UNITED STATES PATENT AND TRADEMARK OFFICE

APPLICATION NO.	FILING DATE	FIRST NAMED INVENTOR	ATTORNEY DOCKET NO.	CONFIRMATION NO.
09/847,759	05/02/2001	Mark J. Hall	HANBEV.002RA	6043
20995 7590 02/18/2009 KNOBBE MARTENS OLSON & BEAR LLP 2040 MAIN STREET FOURTEENTH FLOOR IRVINE, CA 92614				
EXAMINER STRIMBU, GREGORY J				
ART UNIT 3634		PAPER NUMBER		
NOTIFICATION DATE 02/18/2009		DELIVERY MODE ELECTRONIC

Office Action Summary

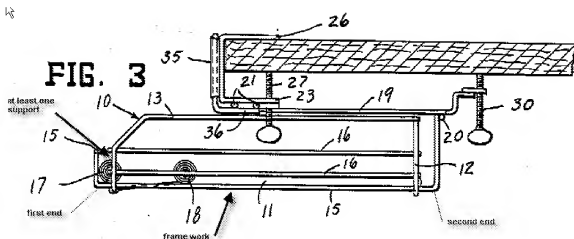
Claims 5, 18 and 56 are rejected under 35 U.S.C. 102(b) as being anticipated by Dickson (US 3007580). Dickson discloses a shelf structure 10 comprising:

a front rod member 21 and at least one other rod member 21 rearwardly spaced from the front rod member and, together with the front rod member, defining a first plane;

a framework (not numbered, but shown in figure 3) defining a second plane; and
at least one support (not numbered, but comprising one of the vertical portions of the rod 13) connecting at least the front rod member and the framework, wherein at least a portion of the framework (not numbered, but shown in figure 3) extends at least forward of a projection 36 of the front rod member 21 thereon with a stop comprising the U-shaped portion of 15, the stop extending in a direction from the second plane with at least a component toward the first plane, and

wherein the framework comprises further rod members 15 each having a first end (labeled below) and a second end (labeled below) and extending from the first end at the stop to the second end that is rearward of a rearward most one of the at least one other rod member 21,

members 22 on the front 21 and other rod members 21, 36 for fixing the framework under another structure.

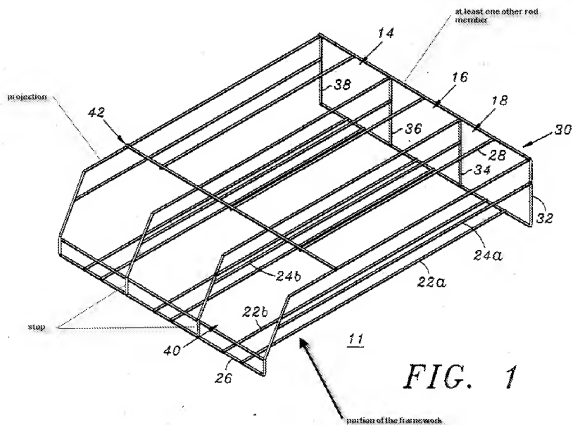
However, Buday discloses a shelf structure 11 configured to rest on and engage one of the shelves which is horizontal or inclined, the shelf structure comprising:

a front rod member 42 and at least one other rod member (not numbered, but shown in figure 1 at the rear of the shelf structure 11) rearwardly spaced from the front rod member 42 and, together with the front rod member 42, defining a first plane and configured to support additional shelving above the first plane;

a framework 22a, 22b defining a second plane; and

at least one support 32 connecting at least the front rod member 42 and the framework 22a, 22b, wherein at least a portion of the framework (not numbered, but shown in figure 1) extends at least forward of a projection (labeled below) of the front rod member 42 thereon with a stop (not numbered, but comprising one of the rods extending between the rod 26 to the rod extending above and parallel to the rod 26), the stop extending in a direction from the second plane with at least a component toward the first plane;

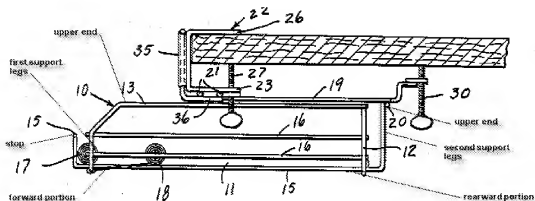
Dickson discloses a rack 10 comprising

- a support assembly 15 having a forward portion (labeled below) and a rearward portion (labeled below) and being configured to support a plurality of beverage containers;

- a first pair of support legs (labeled below) having lower ends connected to the forward portion;

- and a second pair of support legs (labeled below) having lower ends connected to the rearward portion, each of the first and second pairs of support legs having upper ends (labeled below) configured to hang the rack from a shelf disposed above the rack;

- a spacing defined between the upper ends of the second pair of support legs and the rearward portion of the support assembly sized so as to allow the beverage containers to be inserted between a rear portion of the shelf and the rearward portion of the support assembly;

- a stop (labeled below) disposed at the forward portion of the support assembly, wherein the first and second pairs of support legs are sized, i.e., the second pair of support legs are longer than the first pair of support legs, such that the forward portion hangs lower than the rearward portion when the rack is hanging, by the upper ends of the first and second pairs of the support legs, from a horizontal shelf. It should be noted that the rack 10 of Dickson, although not shown, is capable of hanging with the front portion lower than the rear portion by merely adjusting the threaded fastener 30

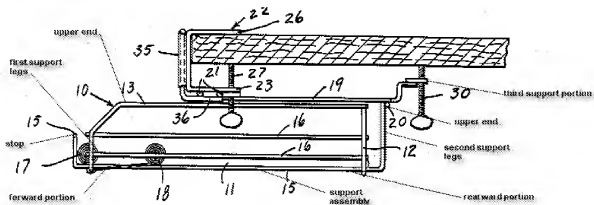
a support assembly (labeled below) having a forward portion (labeled below) and a rearward portion (labeled below), the support assembly defining a support surface configured to support a plurality of cylindrical beverage containers;

a stop (labeled below) disposed at the forward portion of the support assembly;
first and second support portions 22 disposed at the forward portion of the support assembly, the first and second support portions including upper ends, respectively, adapted to be disposed above the plurality of cylindrical beverage containers supported on the support surface;

at least first and second apertures (not numbered, but comprising the apertures through which the fasteners 27 extend) disposed adjacent the upper ends of the first and second support portions, respectively, the first and second apertures being configured to receive fasteners 27 for supporting the forward portion of the support assembly from a shelf 32 above the support assembly, the first and second apertures being spaced rearwardly from the stop;

a third support portion (labeled below) disposed at the rearward portion of the support assembly, the third support portion including an upper end (not numbered, but shown in figure 3); and

at least a third aperture (not numbered, but comprising the aperture through which the fastener 30 extends) disposed adjacent the upper end of the third support portion, the third aperture being configured to receive a fastener 30 for supporting the rearward portion of the support assembly from a shelf above the support assembly;

wherein the third aperture is spaced from a rearward-most portion of the rearward portion of the support assembly such that cylindrical beverage containers can be placed onto the rearward portion of the support assembly when the third aperture is connected to a shelf 32 disposed above the support assembly by fasteners. Dickson is silent concerning a panel configured to support a label and a fourth support portion.

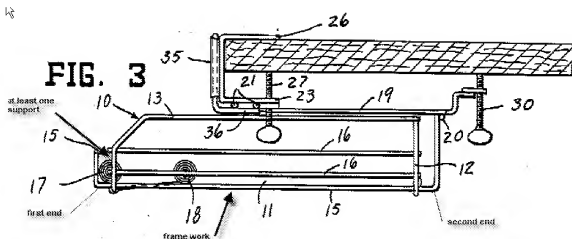
With respect to the applicant's comments concerning Dickson, the examiner respectfully disagrees. Dickson, in figure 1 and 3 shows at least one support connecting the front rod member 21 to the framework. The at least one support comprises the vertical portion of the rod 13 as shown in figure 3 below.

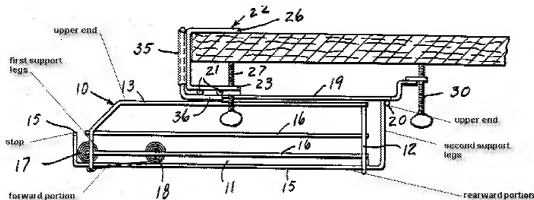
Additionally, Dickson, as shown in the figure below, discloses first support legs which are shorter than second support legs and the entire shelf structure 10 can be positioned such that the first support legs are lower than the second support legs via the screw 30 when the shelf structure 10 is hanging from a shelf.

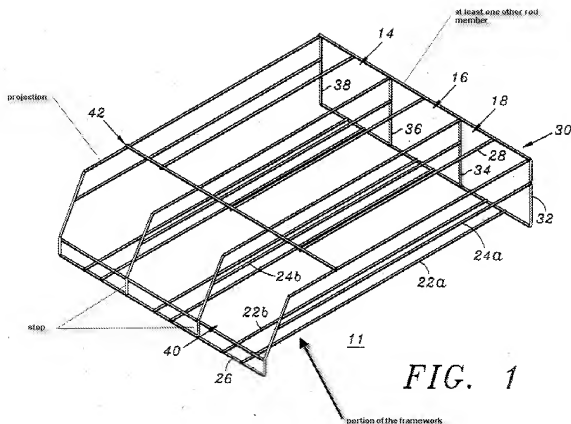
With respect to the applicant's comment concerning the rejection of claims 1-4, 15-17, 53 and 62 as being unpatentable over the admitted prior art in the preamble of Jepson claim 1 in view of Buday (US 5240124), the examiner respectfully disagrees. As shown in figure 1, Buday discloses at least one support 32 which connects the front rod member 42 via the members 28 to the framework 22a, 22b. The applicant's argument to the contrary is analogous to arguing that a person's foot is not connected to his/her head.
